Bonnie Brae 3<sup>RD</sup>  
Addition

March 12, 1993

Re: Pool Roof Top  
8501 E. Douglas

EXHIBIT F

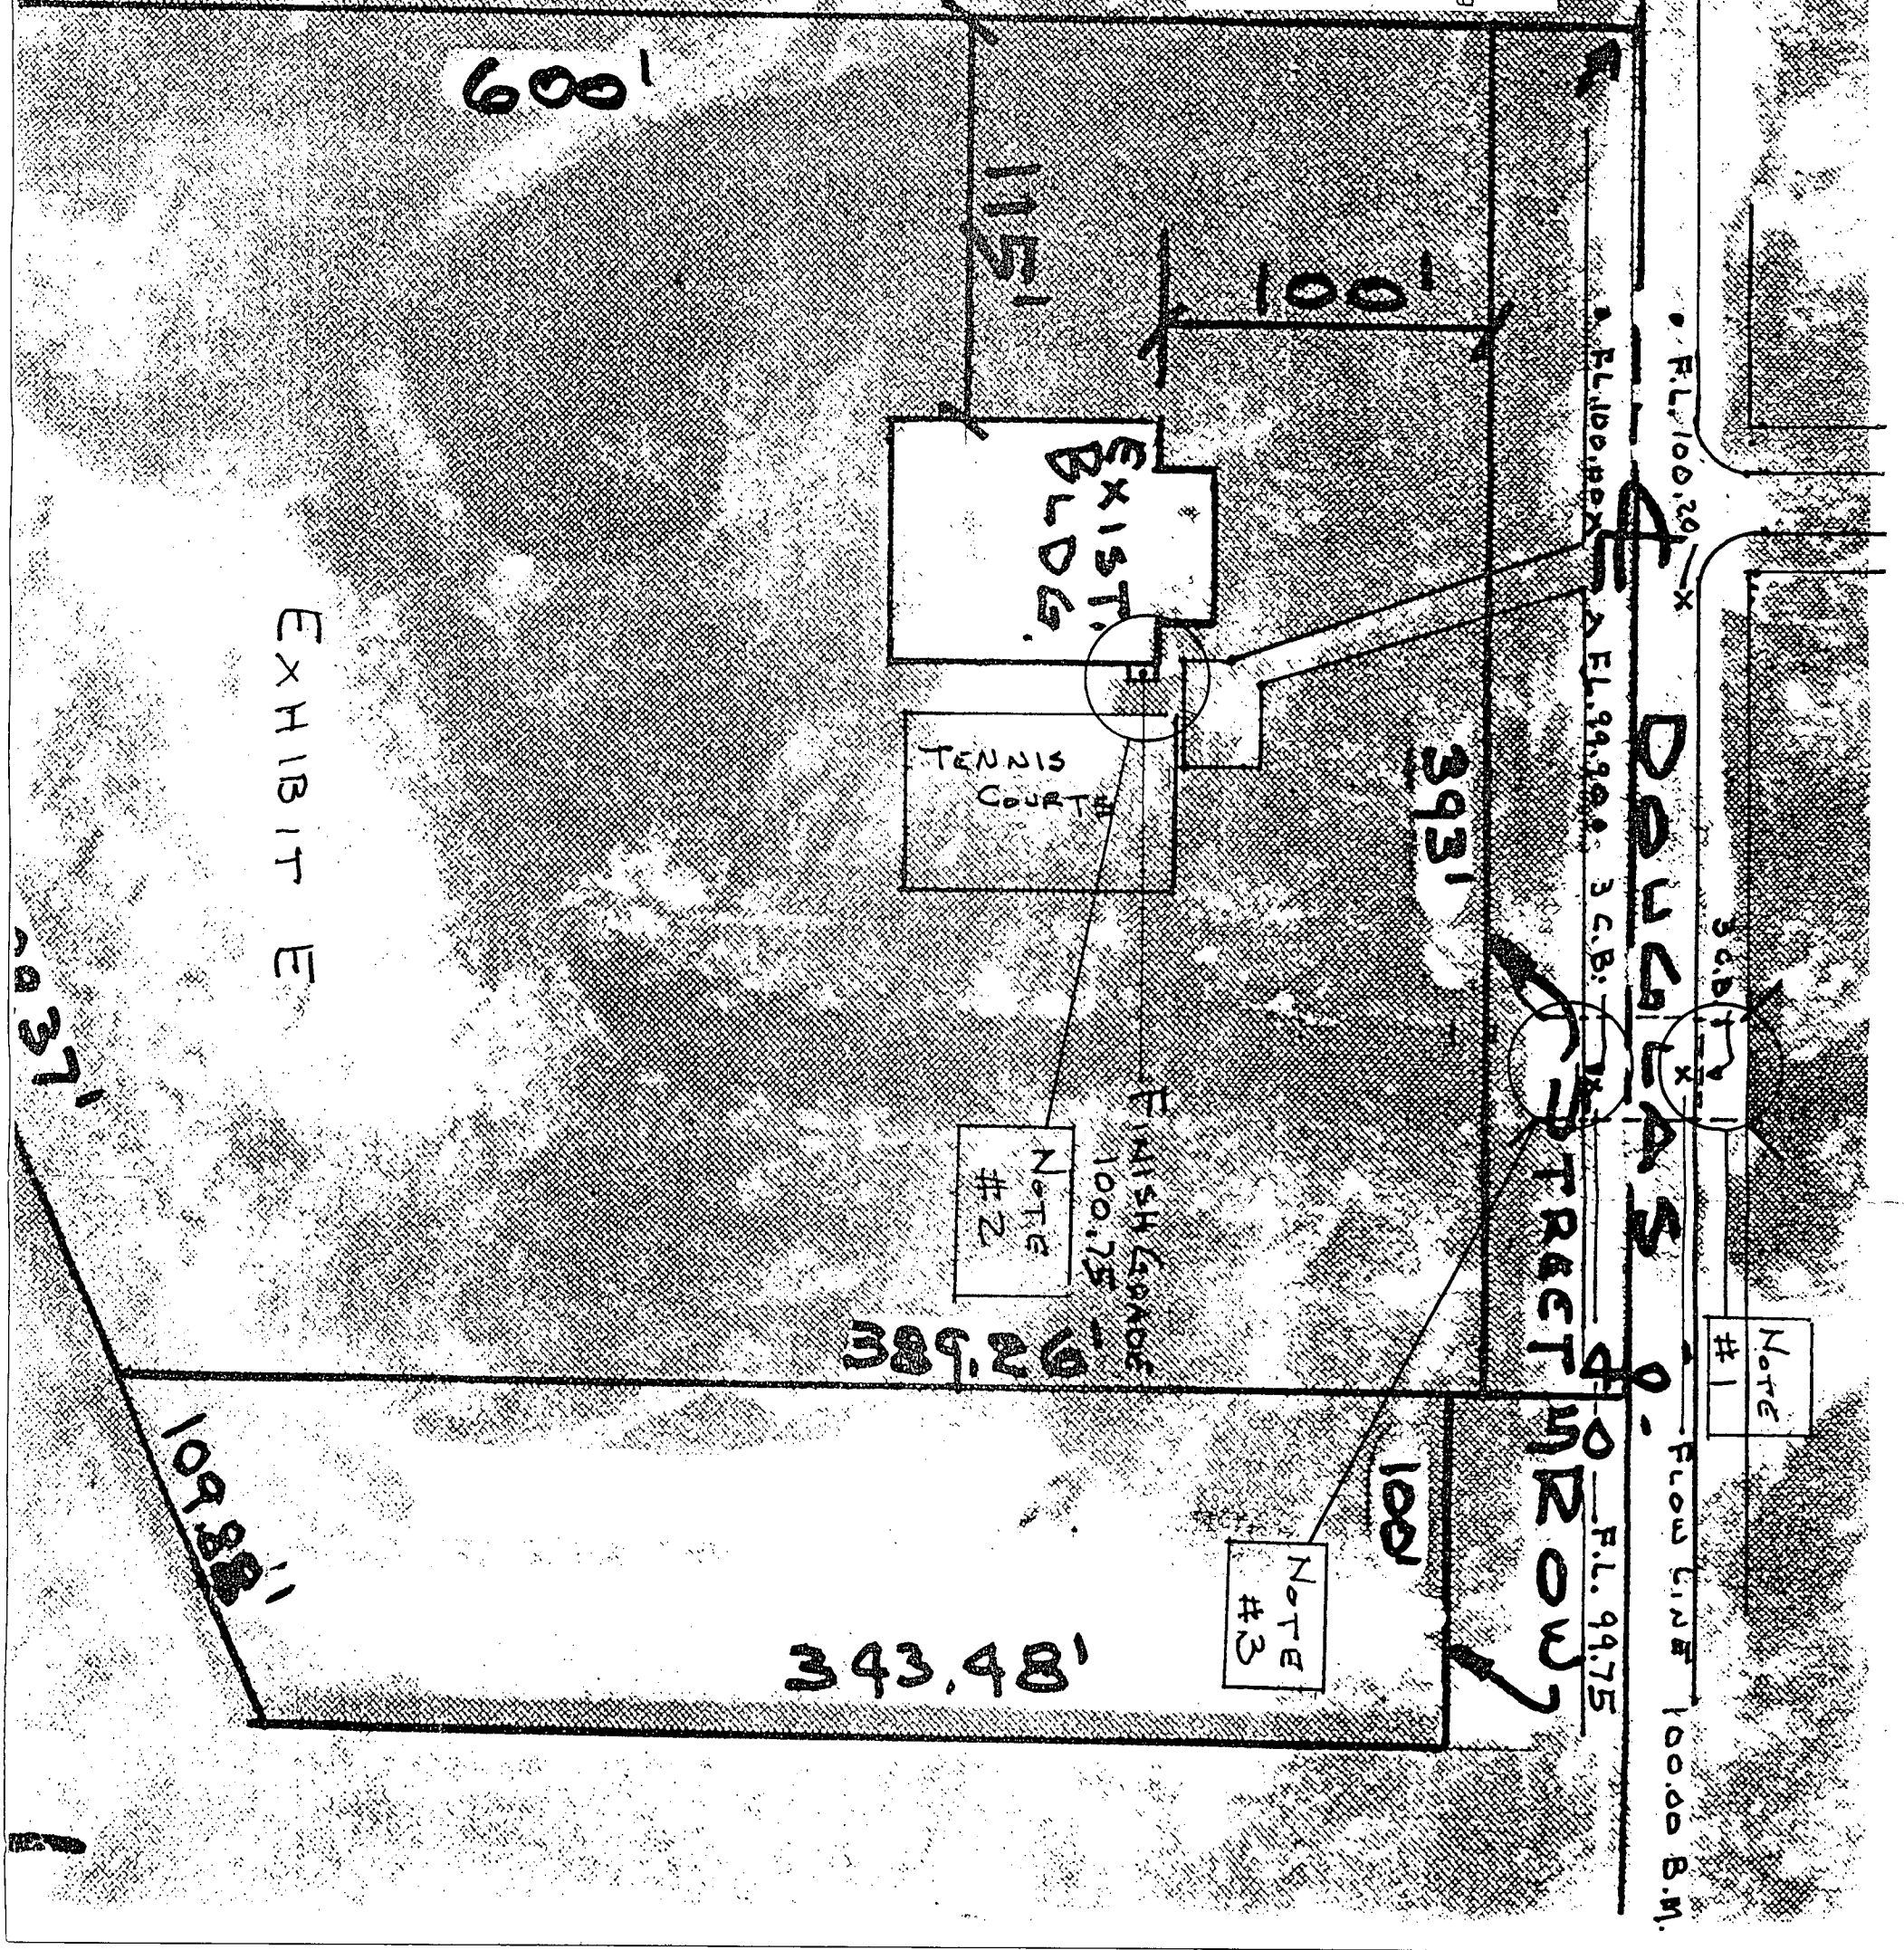
NOTE #1. LEW Field Shot of flow line at culvert center line is Bench Mark. Reading is 100.00. In conversation with Vicki Huang I was told to add .55 to get to top of curb which has a reading of City Datum of 150.57. Add to this 1187.40 to bring to MSL it comes to 1337.97 as indicated below.

NOTE #2. LEW Field Shot of concrete door slab at Pool Building is 100.75. This is .20 higher than top of curb in Note 1.

NOTE #3. Flood Plain map provided by City shows a reading of 1337.10 at this point. This means basic grading about building is 1.07 feet above Flood Plane information provided by Vicki Huang.

It should also be noted that the Flood Plane level at the south side of the site as shown by the Flood Plane map is 1336. This means grade at building is 2.07 above the Flood Plane at this comparison. The building is half way between the two readings and it is logical to assume that it should be averaged or 1.57 feet above the Flood Plane in the area.
